Settings for the tube calibration

Review of Scans from Indian Point

Figure 1 Profile of the defect in tube R2 C69 of steam generator 24 as measured with the high-frequency plus-point at 1000 kHz and 800 kHz.

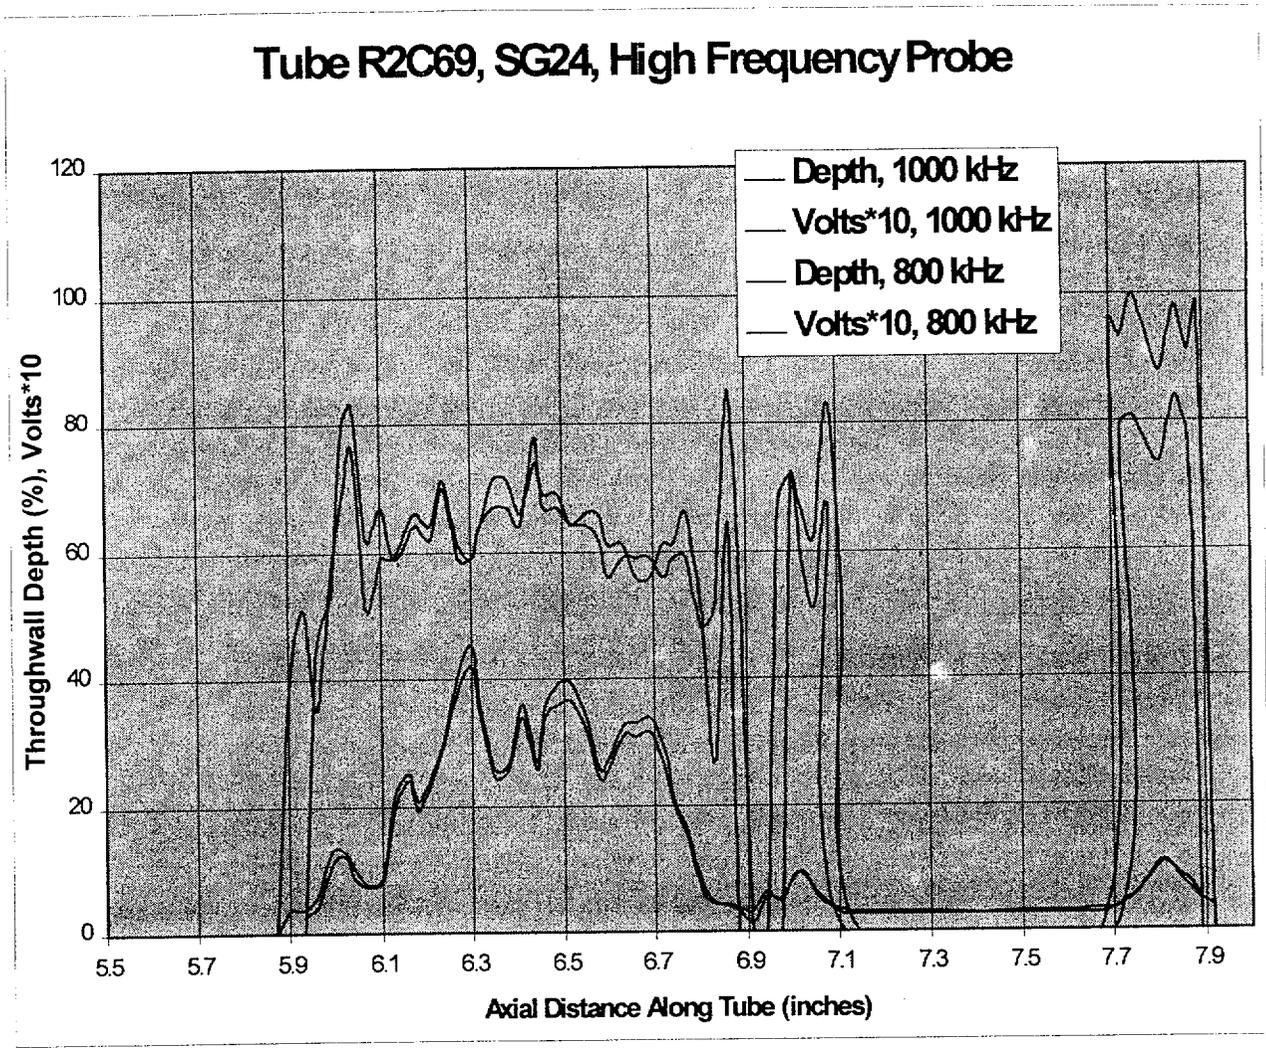
I believe that defect with a maximum voltage of 1.0 volt or higher should be detected. Once this defect has been detected, it can be tracked through the noise as small as about 0.2 to 0.4 volts. However, there will be considerable error in the measurement of the depth at voltages below 1 volt. In Figure 1 we show the profile of the defect in tube R2 C69 of steam generator 24. The tube has been profiled with the high-frequency probe at 1000 kHz and 800 kHz. The depth and the voltage (times 10 to fit on the scale) at each frequency is given. The voltage measured for the 1000 kHz is slightly higher than that for the 800 kHz. The signal-to-noise for the 800 kHz may be slightly better, since od indications are rotated more horizontal, while at 1000 kHz the rotation

ured at the two frequencies is about the same. However, this tube had very little noise even with the old mid-range plus-point probe. The indication located at about 7.8-inches has a maximum value slightly greater than a volt, and the agreement between the two frequencies is not as good in this region. This defect at 7.8-inches was not included in the profile mid-frequency plus-point results furnished by the utility.

For indications on the tube id, the voltage increases as frequency increases. The opposite effect is observed for indications on the tube od. Also, for od indications, the phase rotates clockwise as the frequency decreases. For id defects, with the calibration used above, the phase stays constant with frequency. This tube leaked at 5173 psig in the utility test.

Figure 2 Profile of the defect in tube R2C71 in steam generator 24 as measured with the high-frequency plus-point at 1000 kHz and 800 kHz.

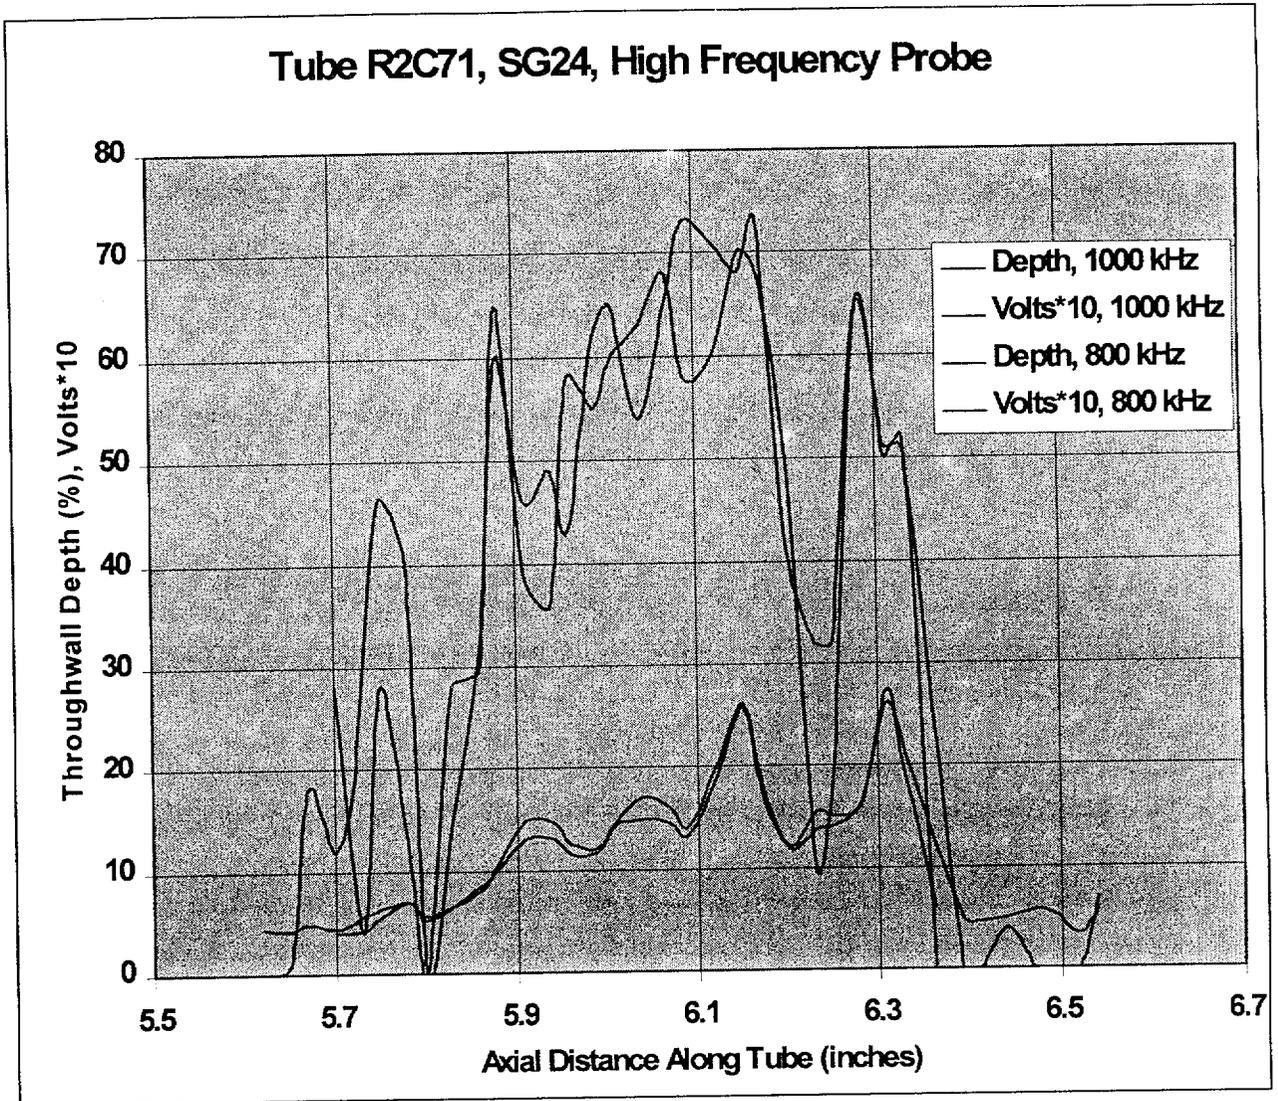
In Figure 2 we show the profile of tube R2C71 of steam generator 24. This tube had a small leakage at 2841 psig. The pressure could not be increased past 4500 psig due to the lack of capacity of the pump. Note that this tube was missed in the earlier inspection with the mid-range probe. The depth profiles at 1000 kHz and 800 kHz do not match each other as well, which is

due mostly to the low voltages that are present. This tube has about the same depth measurements as tube R2C69 in Figure 1, but the voltage values are only about half as large. Note the depth measurements do not agree well where the magnitude of the voltage is low. When the voltage falls below 0.5 volts, the depth measurement becomes quite inaccurate.

Figure 3 Profile of the defect in tube R2 C74 of steam generator 24 as measured with the high-frequency plus-point probe at 1000 kHz and 800 kHz.

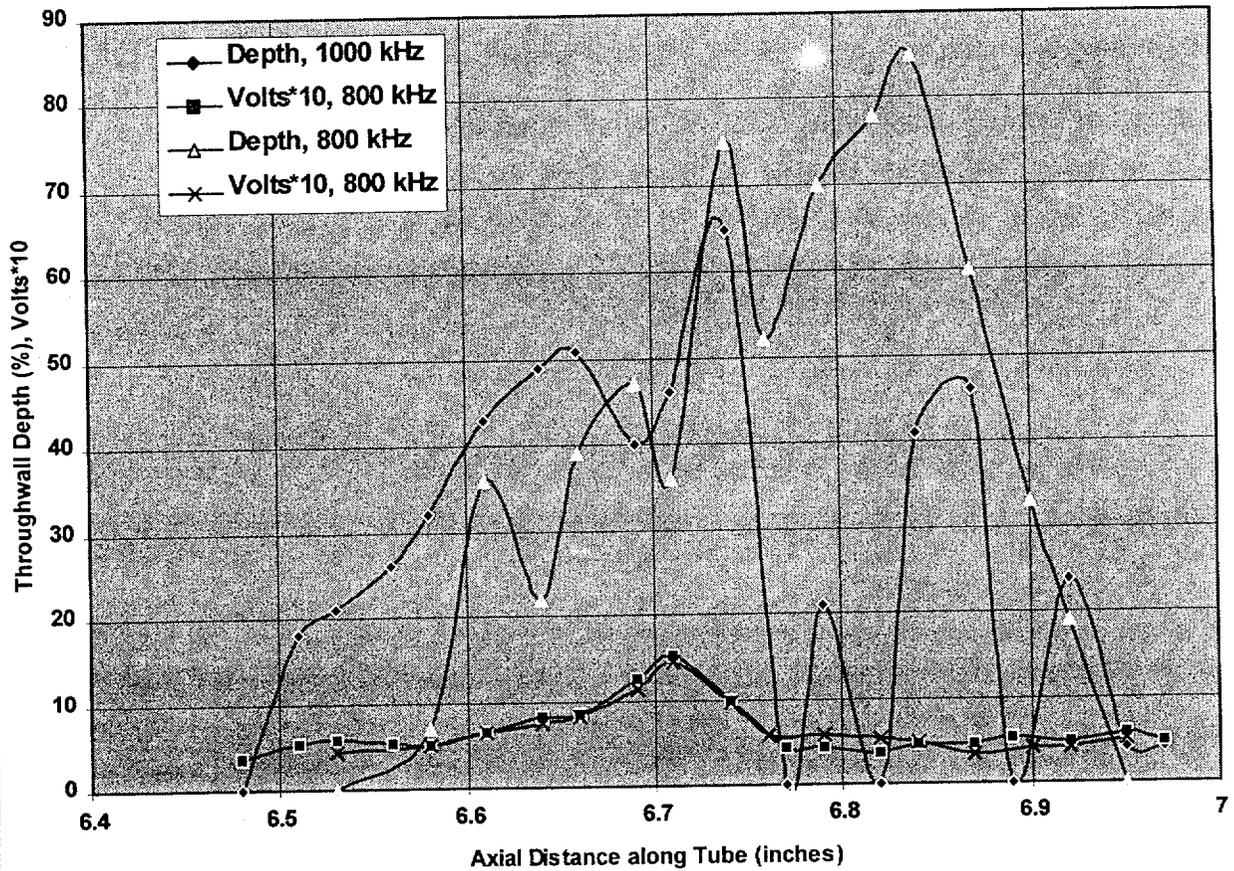
The profile plot for tube 2-74 is shown in Figure 3. The defect

has a maximum voltage of only about 1.5 volts. There is very poor agreement in the depth measurement at the edges of the defect where the voltage is small. There was some noise that increased as frequency decreased at the 6.8 to 6.9-inch region of the tube. This tube has a portion of the defect that measures in the 40% to 50% deep range, between 6.6 and 6.7-inches. This shows some of the probe's ability to measure and detect defects in this depth range. Unfortunately, this tube leaked at 5500 psig.

Figure 4 Profile of the defect in tube R2 C4 of steam generator 24 as measured with the high-frequency plus-point at 1000 kHz, 800 kHz and 300 kHz.

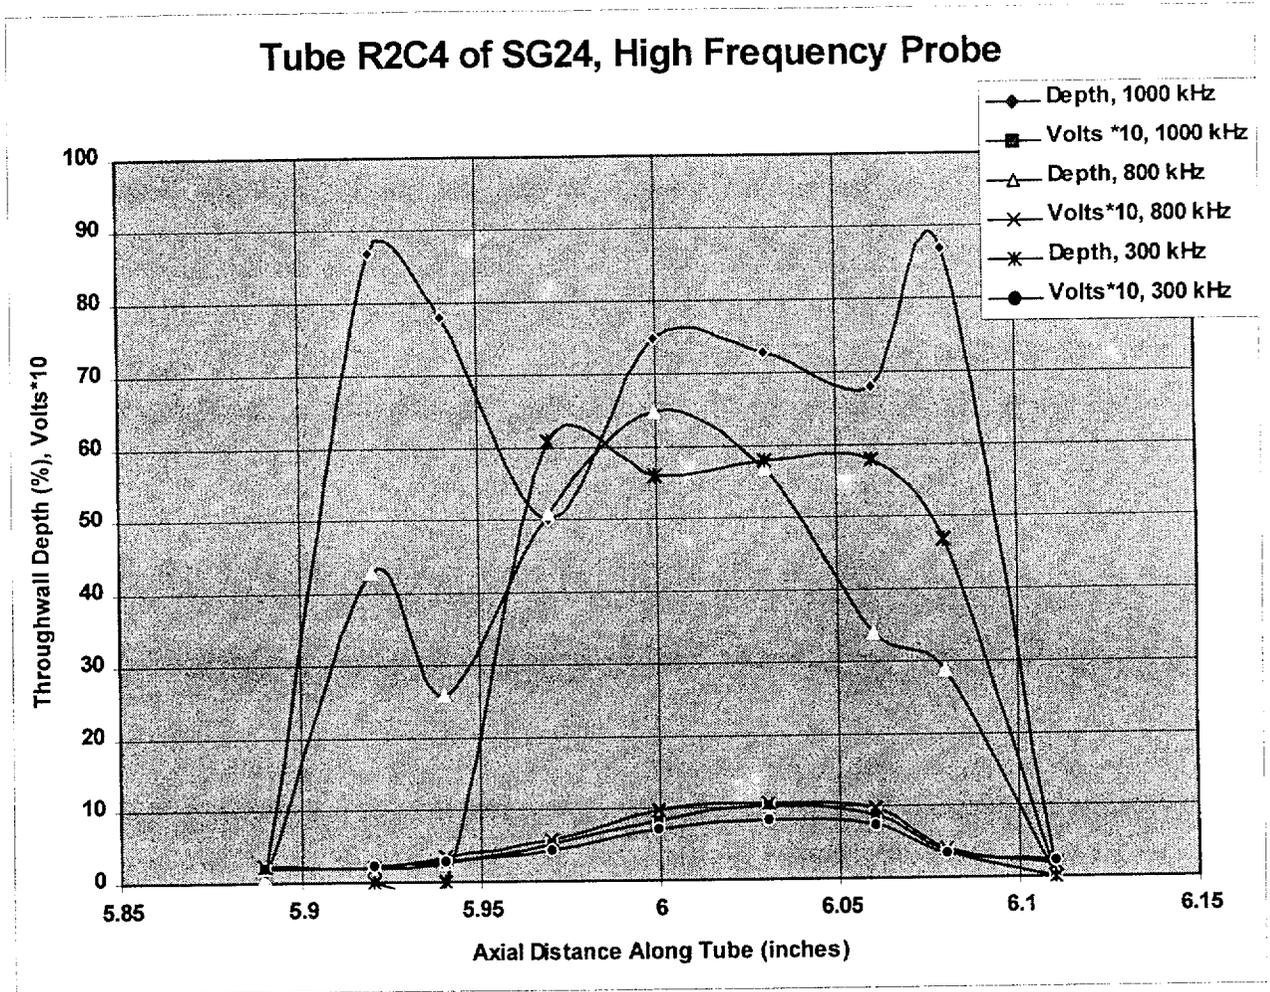
In Figure 4 we show the profile of tube R2 C4 of steam generator 24. This tube was profiled with the high-frequency

at 1000 kHz, 800 kHz and 300 kHz. The maximum voltage measured for this tube was only slightly greater than a volt, which probably has caused the wide variation in depth measurements at the different frequency. This defect is the shortest of all of the defects that we have looked at thus far. This tube did not leak at 5500 psig.

Figure 5 Profile of the defect in tube R2 C72 of steam generator 24 as measured with the high frequency plus-point at 1000 kHz and 800 kHz.

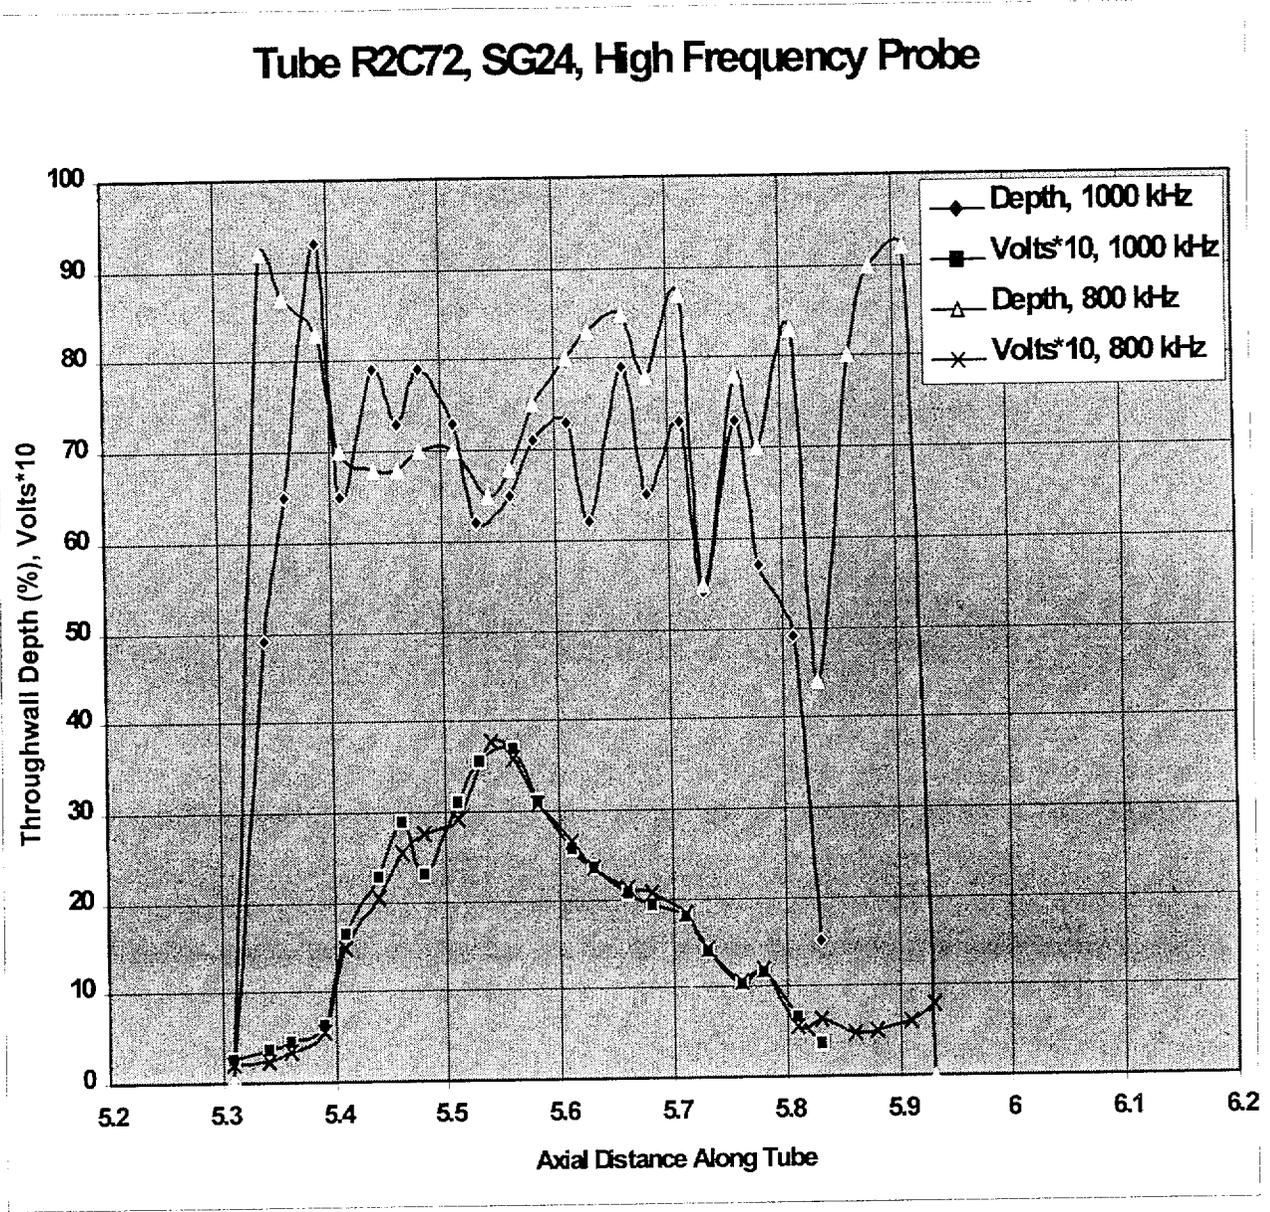
In Figure 5 we show the profile of tube R2 C72 in steam generator 24. This tube has a relatively

ly high voltage and the phase measurements show a deep depth. However, this tube did not leak at the 5500 psig pressure test, although tubes with more shallow defect measurements and lower voltages did leak. As with the previous tubes, the depth measurements made at higher-voltage agree but not for the lower voltage measurements. There appeared to be od deposits that were influencing the signal at the 5.8 to 5.9-inch location.
